CITY OF FORT LAUDERDALE

CASE COMMENT REPORT

CASE NO. UDP-S25012

CASE	UDP-S25012
PROJECT NAME	Las Olas Villa Townhouses
APPLICATION TYPE	Site Plan Level II
APPROVAL LEVEL	Development Review Committee
REQUEST	6-Unit Townhouse Development
APPLICANT	Las Olas Homes, LLC.
AGENT	Stewart Robin & Steven Gaynair, Nest Plans, Inc.
PROPERTY ADDRESS	923 W. Las Olas Boulevard
ABBREVIATED LEGAL DESCRIPTION	Waverly Place 2-19 D Lots 11,12 & S1/2 Vac Alley Lying N Of Said Lots Blk 113
ZONING DISTRICT	Residential Multifamily Low Rise/Medium High Density (RML-25) District
LAND USE	Medium-High Residential
COMMISSION DISTRICT	2 – Steven Glassman
NEIGHBORHOOD ASSOCIATION	Sailboat Bend Civic Association
SUBMITTED	April 11, 2025
COMPLETENESS ISSUED	April 22, 2025
EXPIRATION	August 20, 2025 (120 Days)
WAIVER	Not Requested
CASE PLANNER	Trisha Logan, AICP Principal Urban Planner

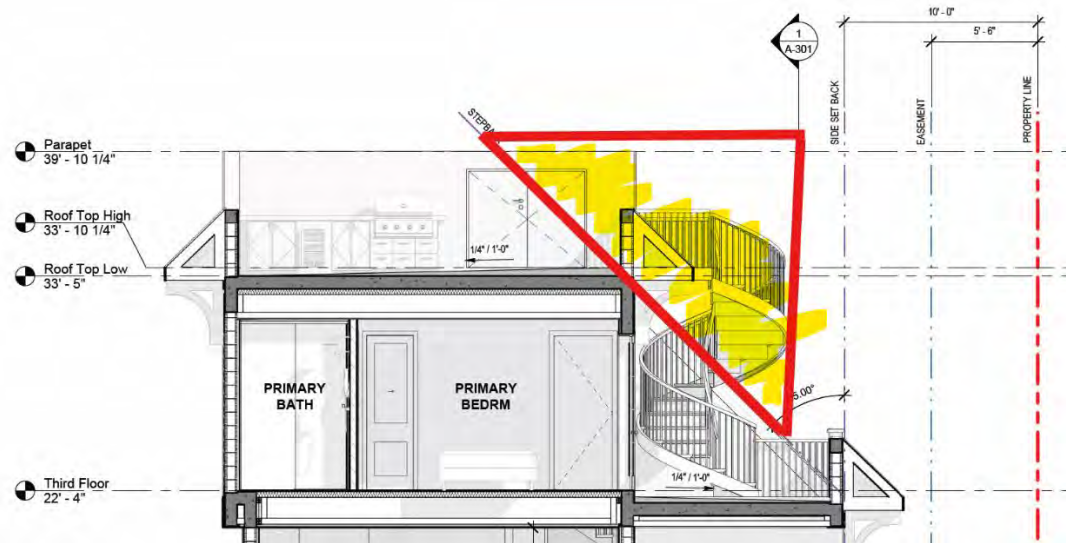
- i. Pursuant to ULDR Section 47-18.33.B.3, a minimum of twenty-five (25) percent of the townhouse group's front facade shall be set back an additional five (5) feet from the rest of the front facade. Provide the specific percentage of setback that the front façade is recessed from the rest of each townhouse group. To mitigate building massing, consider introducing variations in the wall plane along the primary building façade. This could be achieved by incorporating recessed elements or sections into the exterior wall, adding visual interest while maintaining a cohesive rhythm.
